**Subject:** Power Cord Bracket  
**Product(s):** SC750  
SC800  
**System:** On-Board Charging  
**Number:** TSB-FC-2013-112  
**Date:** 12 July 2013  
**ODM/ECO:** None  
**Urgency:** Level 3

## TECHNICAL SERVICE BULLETIN

FIG A

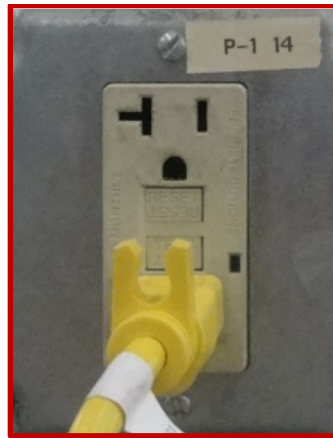
**WARNING:** ALWAYS USE THE WALL PLUG TO CONNECT AND DISCONNECT POWER TO THE CHARGER (FIG A)

FIG B

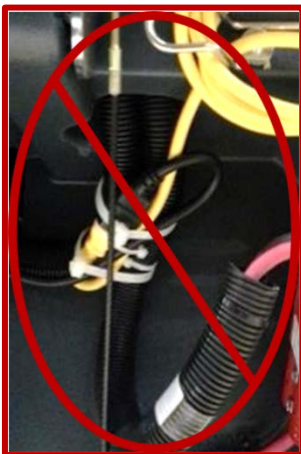
PROPERTY DAMAGE OR PERSONAL INJURY MAY RESULT IF THE OPERATOR OF THE MACHINE USES THE CHARGER TO EXTENSION CORD CONNECTION POINT AS A LOCATION TO CONNECT AND DISCONNECT THE ONBOARD CHARGER POWER. (FIG B) INSPECT THE CORD FOR SIGNS OF DAMAGE (IE PITTING, DISCOLORATION, DEGRADATION) AS SHOWN IN FIG C INDICATED BY THE RED ARROW BELOW.

FIGURE 1

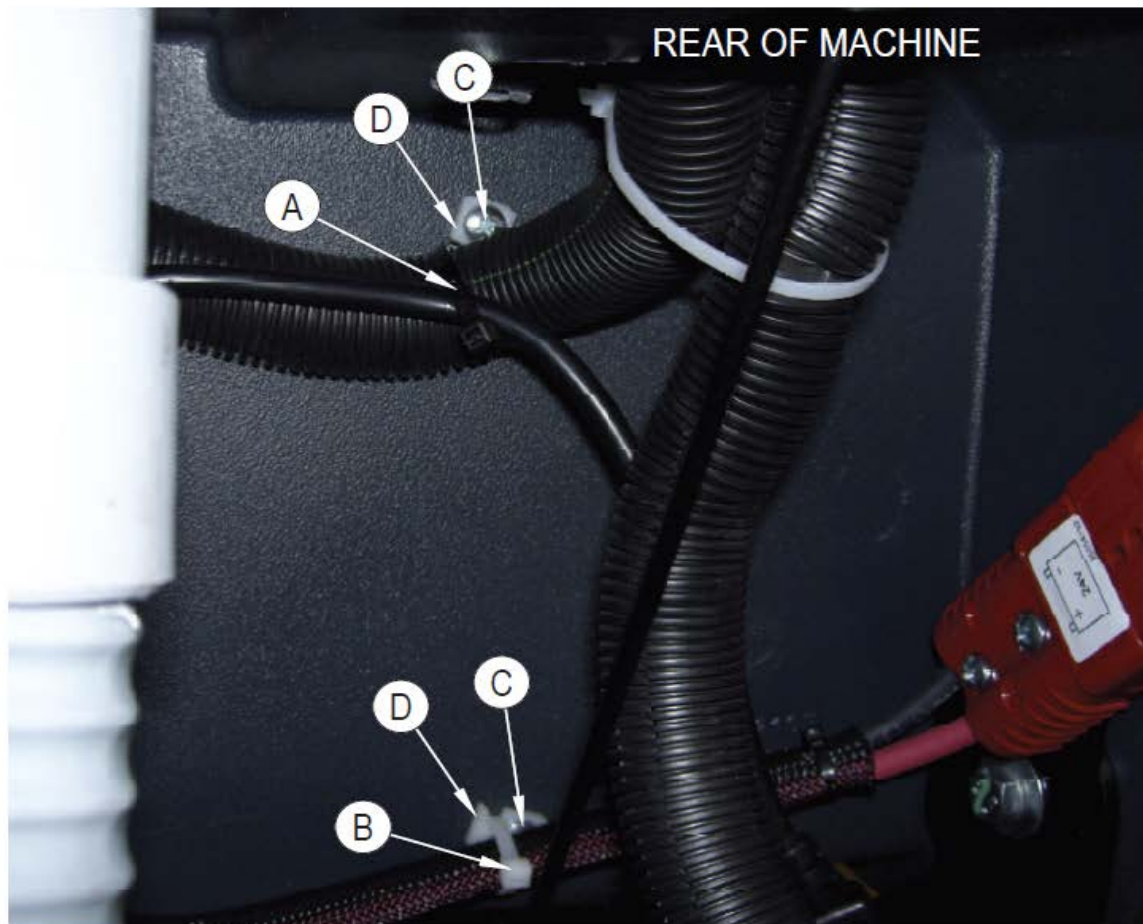
- 1 SEE FIGURE 1. Cut Cable Ties (A & B).
- 2 Remove Screws (C) and save for reuse.
- 3 Discard Mounting Tabs (D).
- 4 Cut the plug off the end of the battery charger cord attached to the battery charger.
- 5 Discard the old power cord that plugged into the battery charger.

FIGURE 2

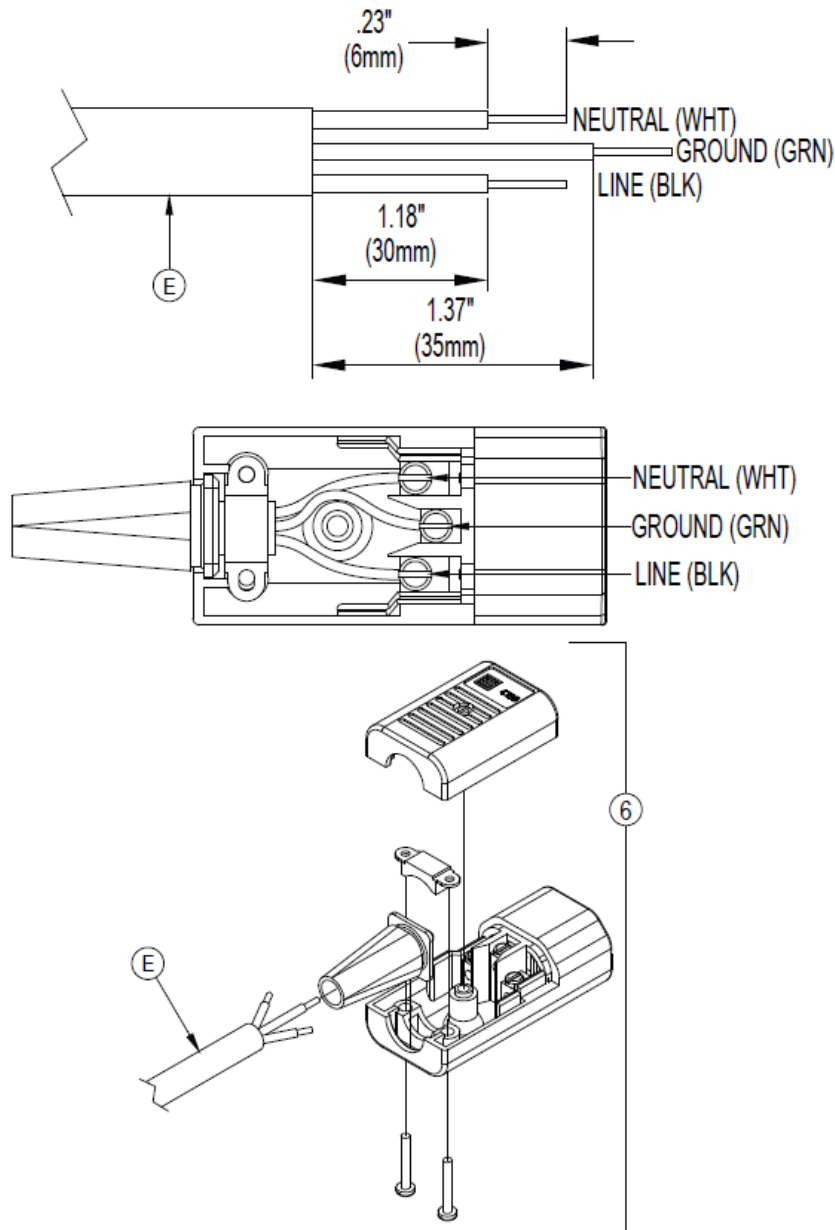
- 6 SEE FIGURE 2. Strip the end of the Charger Cord (E) as shown.
- 7 Disassemble Plug (6) and install on Charger Cord (E) as shown.

FIGURE 3

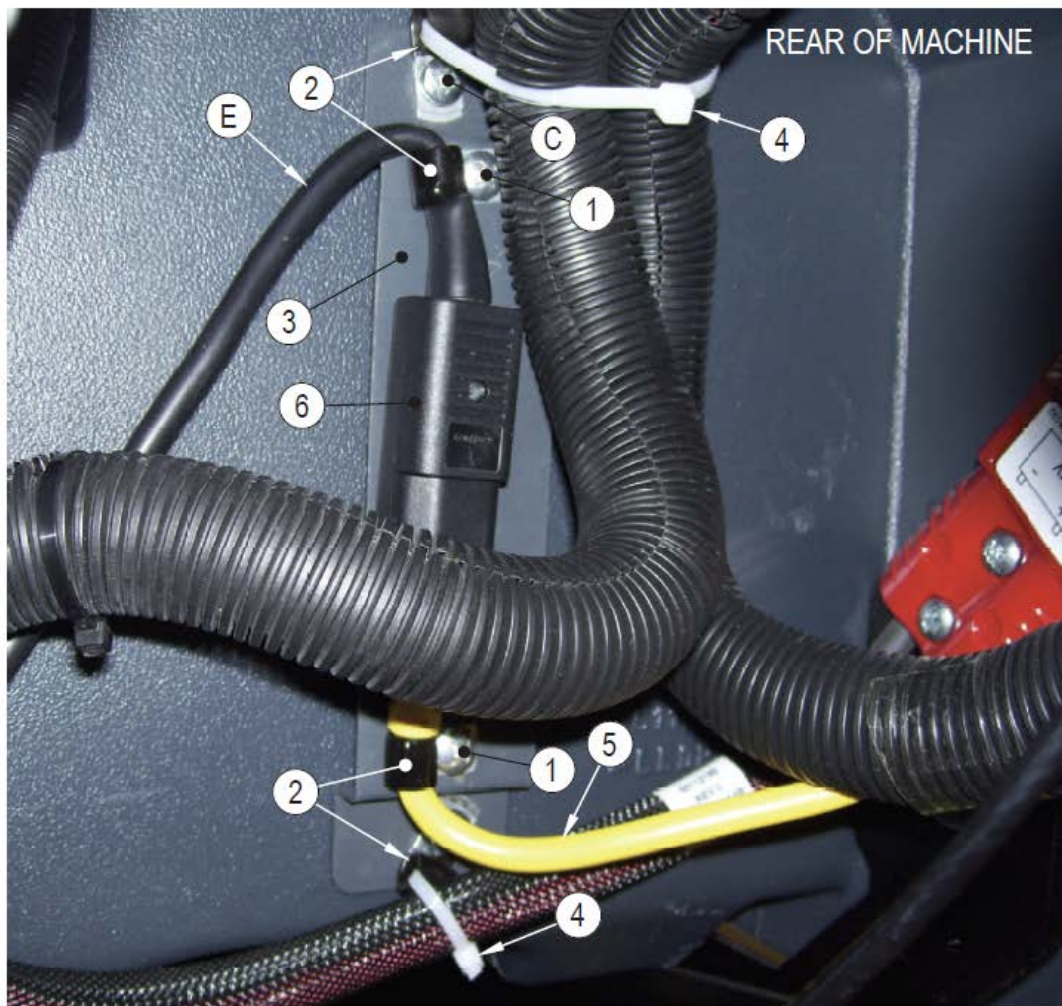
- 8 SEE FIGURE 3. Install Power Cord Bracket (3) as shown using Screws (C) removed in FIGURE 1 and Hose Support Clamps (2). **NOTE:** Bracket (3) mounts to the same holes as the Mounting Tabs (D) removed in FIGURE 1
- 9 Mount Charge Cord (E) to Bracket (3) as shown using Screw (1) and Hose Support Clamp (2).
- 10 Plug Charge Cord (5) into Plug (6) and then secure to Bracket (3) using the remaining Hose Support Clamp (2) and Screw (1). **NOTE:** Kit 56383394 includes two Cords (5). Use the appropriate cord depending on your needs.
- 11 Use the two Cable Ties (4) to replace the Cable Ties (A & B) cut off in FIGURE 1.
- 12 Reconnect the batteries and wrap Cord (5) around the cord wrap on the rear of the machine.
